Road & Bridge Design Publications

Monthly Update – February 2012

Revisions for the month of **February** are listed and displayed below. New special details are to be included in projects submitted for the **May** letting as is stated on the special detail index sheets. Please contact Wayne Pikka (pikkaw@michigan.gov) for any questions related to the road changes or Vladimir Zokvic (zokvicv@michigan.gov) for questions related to the bridge changes.

R-31-F

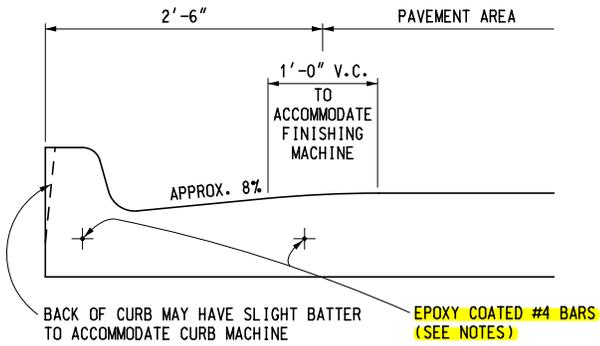
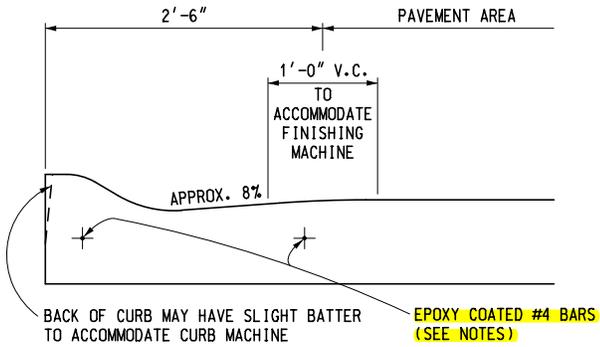
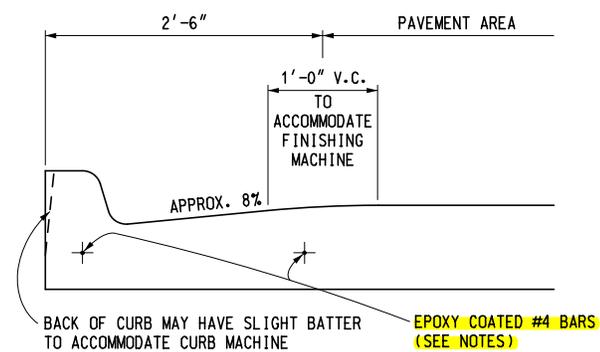
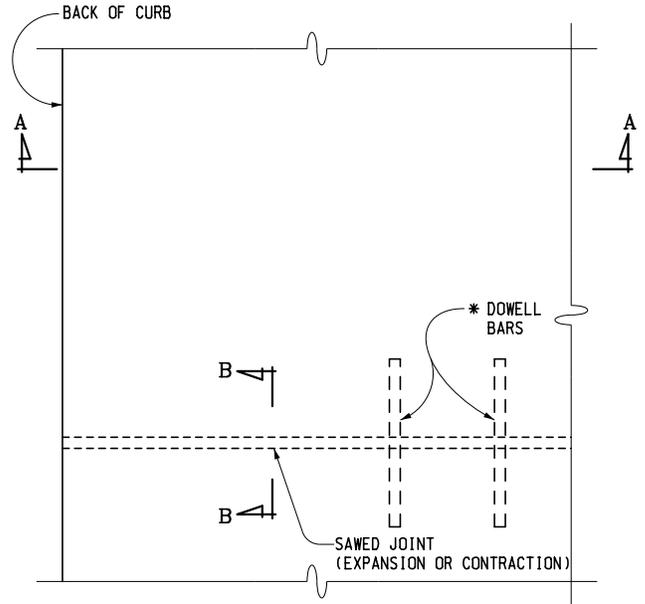
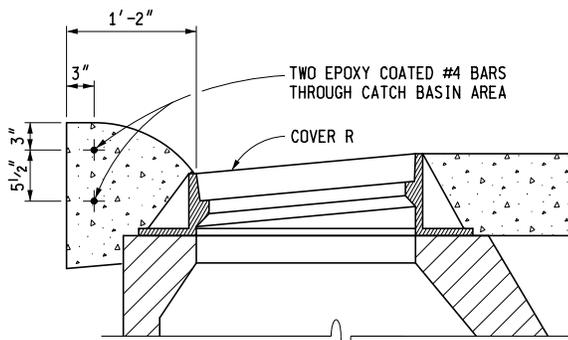
R-31-F: On sheet one, removed the neoprene joint sealer and associated notes and labeled the reinforcing bars, “epoxy coated #4 bars, see notes.” On sheet two in the note section, changed the pay item “aggregate base, concrete” to the current pay item, “aggregate base” and added the following note: “Omit longitudinal reinforcement when curb & gutter is tied to a non-reinforced concrete base course, shoulder, or pavement.”

F.H.W.A. APPROVAL	2-8-2012 PLAN DATE	R-43-I
		SHEET 2 OF 2

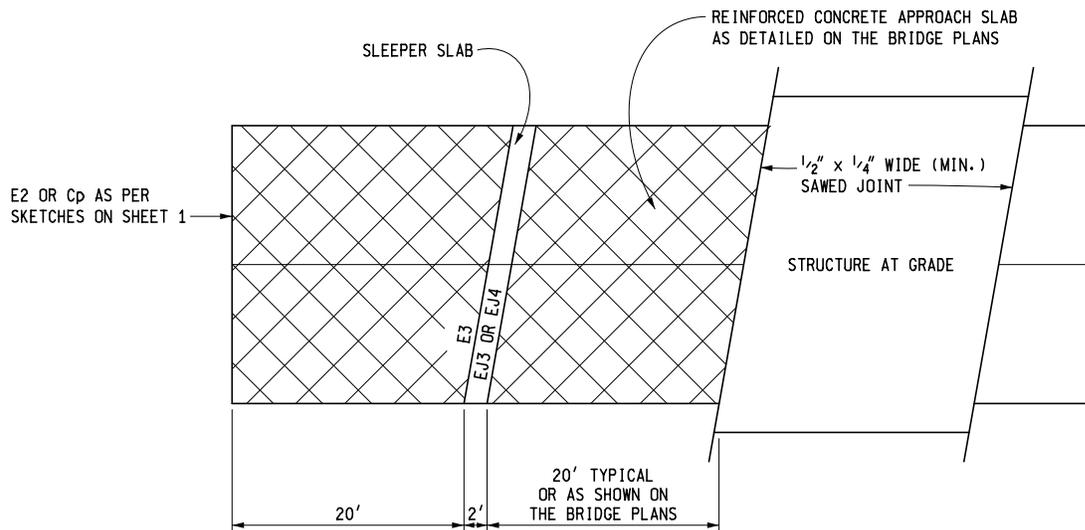
R-43-I: The severe skew details on sheet two were eliminated since they are no longer necessary with the new bridge approach pavement reinforcement.

TEMPORARY CONCRETE BARRIER END SECTION

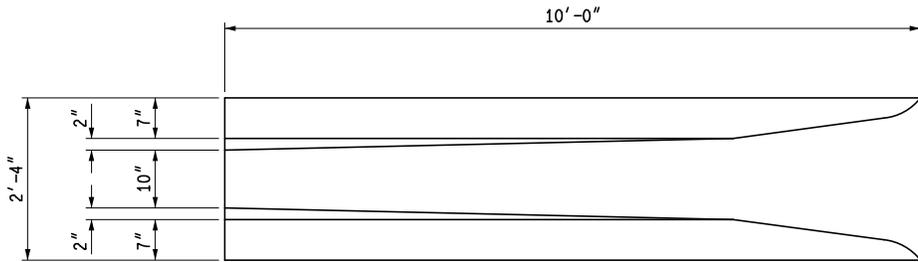
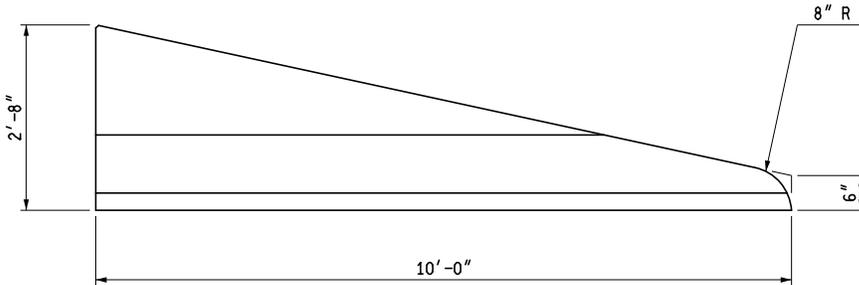
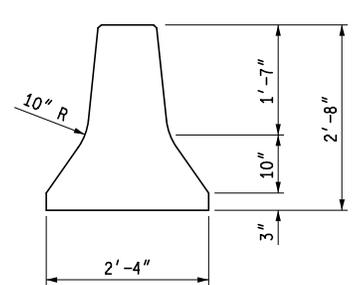
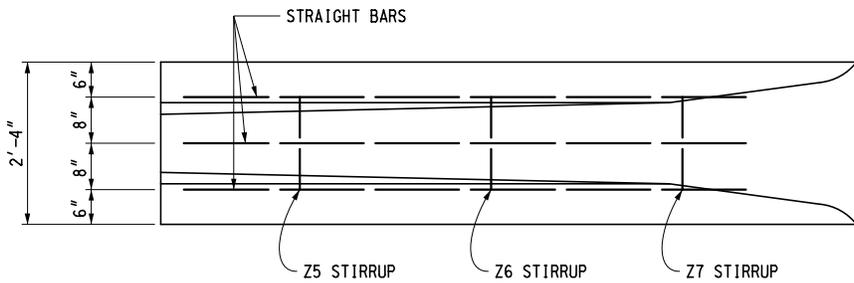
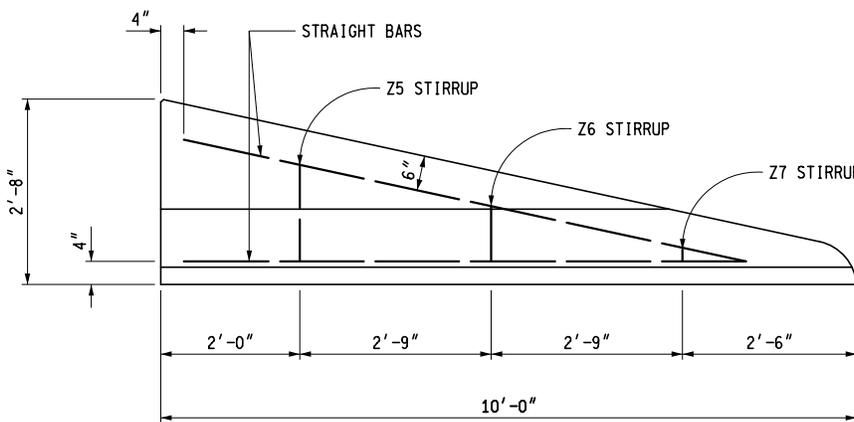
R-126-I: On sheet three, the reference to former standard plan R-125-series was revised to Work Zone Device Special Detail WZD-125-series. In the first note on the note sheet, the reference to R-52-series was eliminated since that standard plan has been eliminated. Also, the temporary concrete barrier end section detail was moved from the deleted R-52-series to this standard plan. The pin and loop connection was removed from these sketches and a note was added which addresses the hardware to connect the end section to the barrier.

NOTE:
HARDWARE USED TO CONNECT THE END SECTION TO TEMPORARY CONCRETE BARRIER MUST MEET THE REQUIREMENTS OF NCHRP 350 OR MASH (TEST LEVEL 3 OR HIGHER).

END WALL ELEVATION

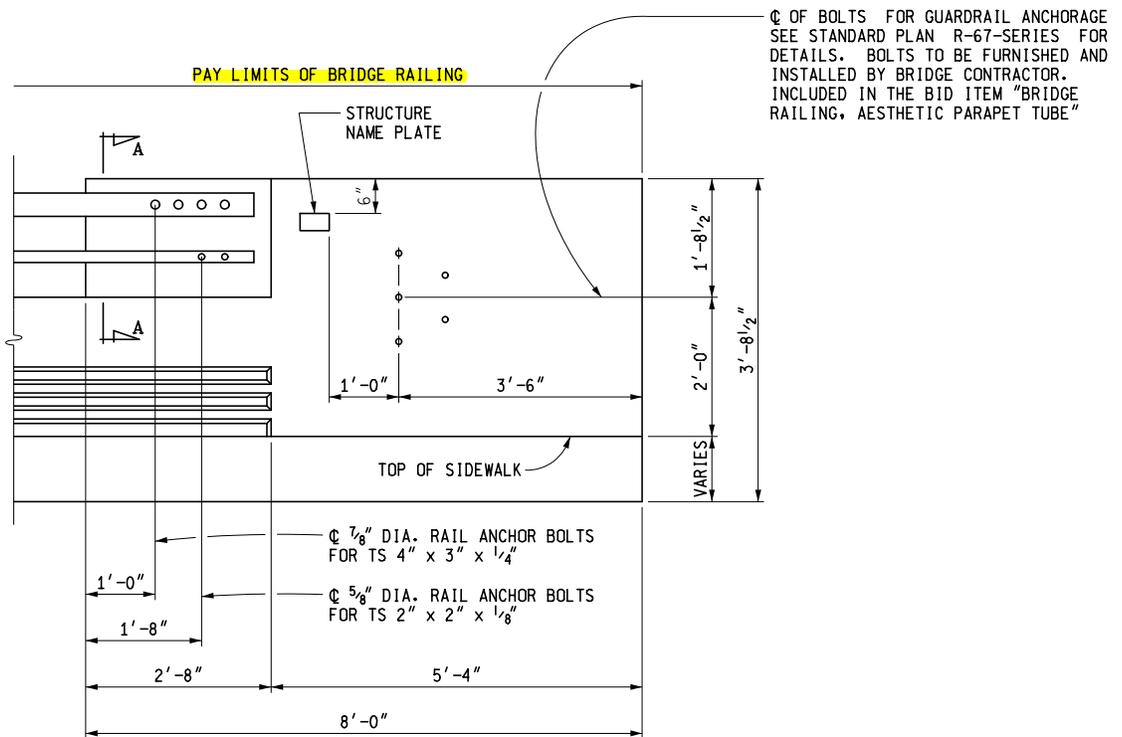
B-25-G: Extended the pay limits of railing to include end walls, per 2012 Standard Specifications for Construction.

6.29.10D

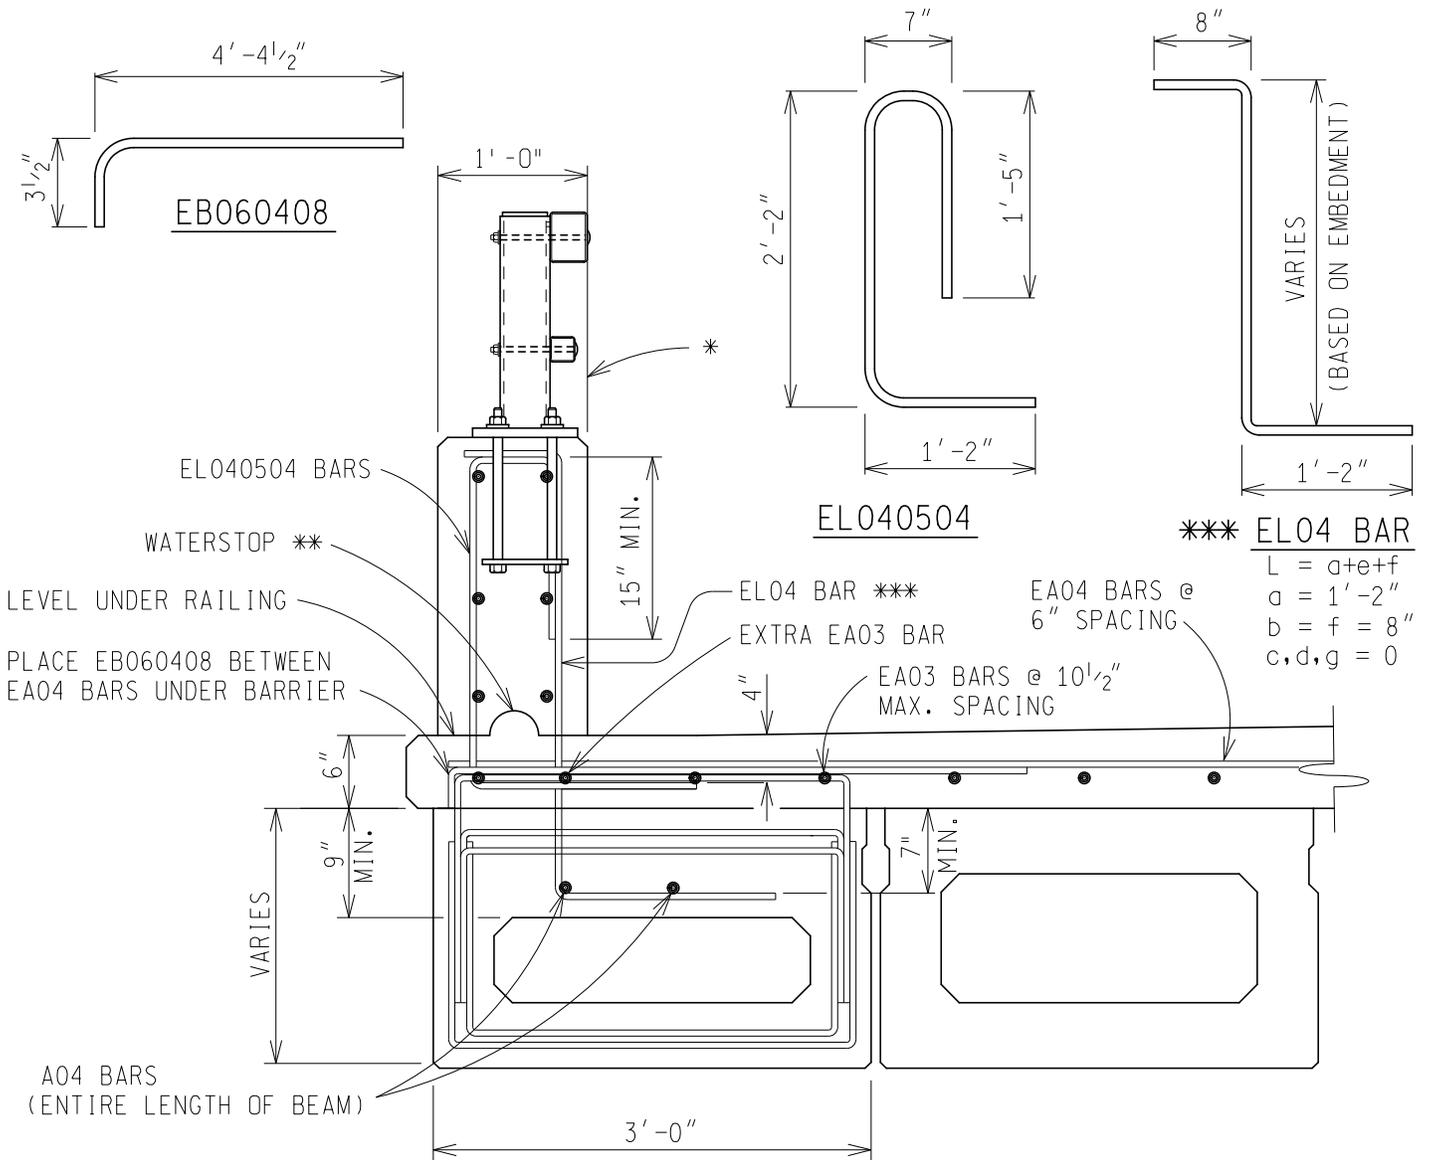
6.29.10D – Updated Angle of Crossing notes; grammatical, file conversion errors.

FOR ANGLE OF CROSSING 70° TO 90° PLACE TRANSVERSE STEEL PARALLEL TO REF. LINE.

FOR ANGLE OF CROSSING < 70° AND SPAN LENGTH > DECK WIDTH PLACE TRANSVERSE STEEL ⊥ TO BRIDGE C.

FOR ANGLE OF CROSSING < 70° AND SPAN LENGTH < DECK WIDTH PLACE TRANSVERSE STEEL || TO REF. LINE.
